**Sewall Wetland Consulting, Inc.**

January 24, 2019

RE: 5637 East Mercer Way – Parcel #1924059312  
City of Mercer Island, Washington  
SWC Job#14-206

**ESA Memorandum dated October 17, 2108**

**CRITICAL AREA ENHANCEMENT PLAN**  
- MI TREEHOUSE LLC -

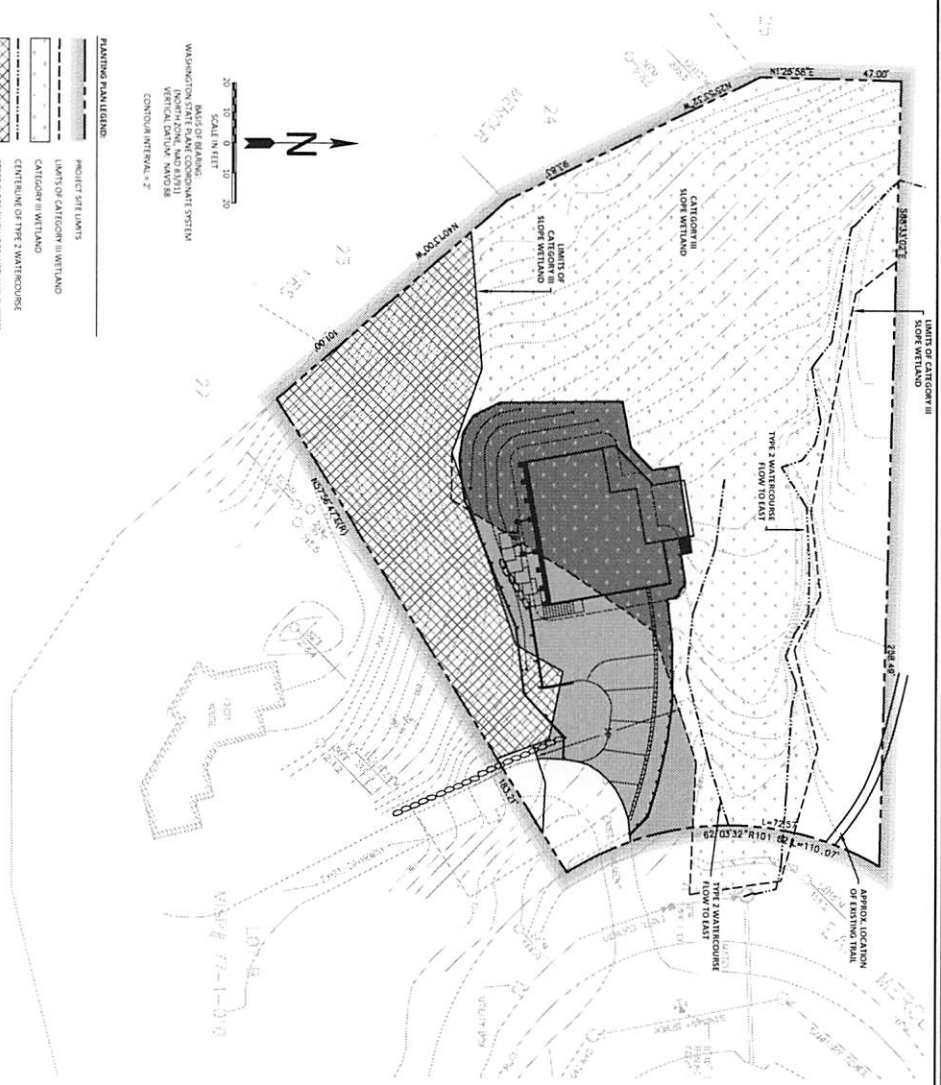
14. Mitigation discussion within the CAR should clarify the type of onsite mitigation.

15. Mitigate onsite to compensate for permanent buffer impacts.

Response: The mitigation for the project will consist of two actions;

1. On-site buffer enhancement to include under planting the existing buffer with conifers, as well as replanting areas that are graded

and under the elevated decks. This is depicted on the attached Critical Area Enhancement Plan revised to 1-24-19.

2. Purchase of off-site credits from the King County Mitigation Reserves program to compensate for permanent wetland impacts.

**Response:** On-site wetland buffer enhancement includes removal of any blackberry and under planting with conifers as depicted on the attached Critical Area Enhancement Plan revised to 1-24-19.

**Planting Plan, Notes, Details, & Monitoring Plan**

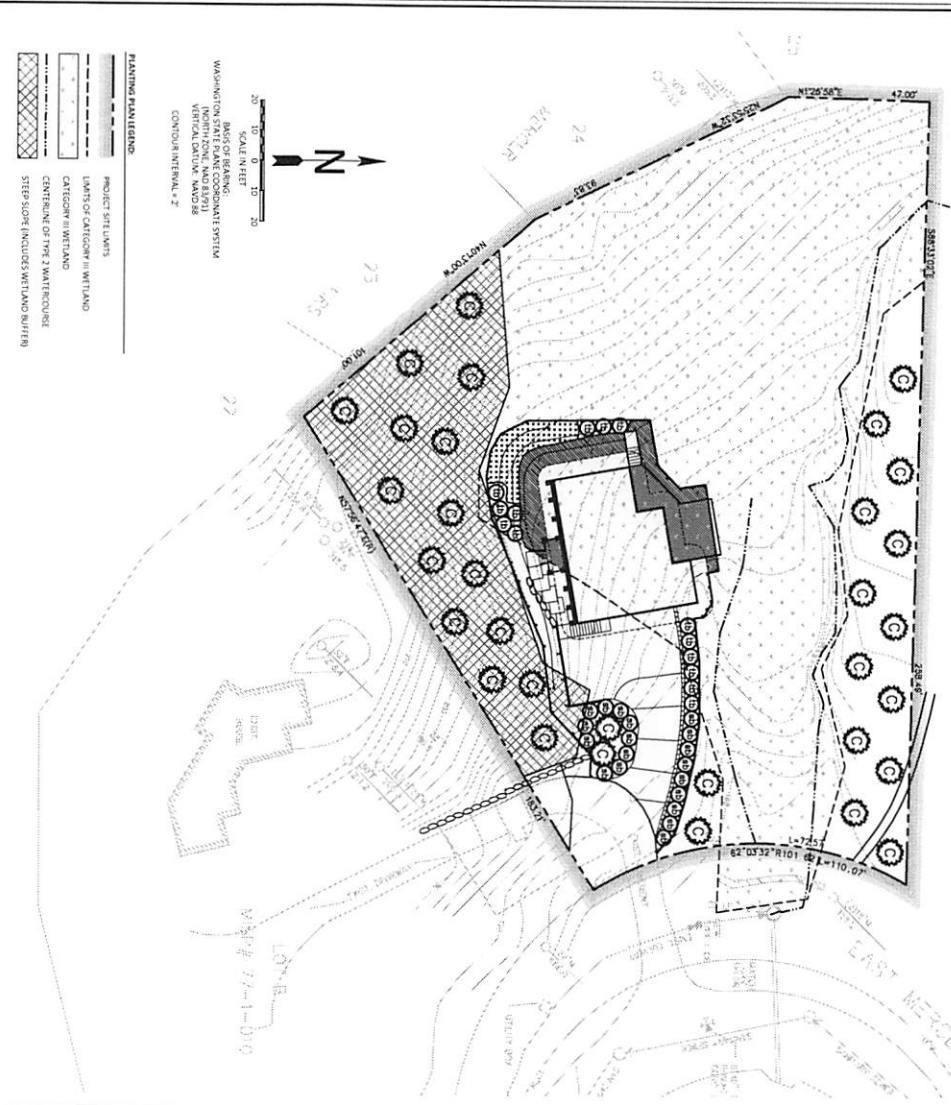
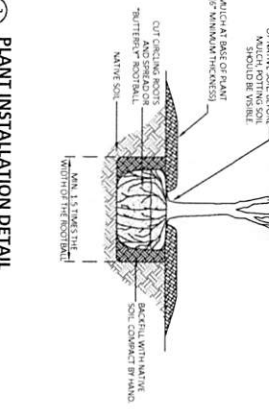
2. Provide rationale to support the determination that decks will result in temporary, rather than permanent, wetland impacts.

Response: Although we are proposing to replant the area under the decks, for the purpose of the impact calculations, we now are including

the decks as an impact. This area will now be replanted with slough sedge as a mitigation action
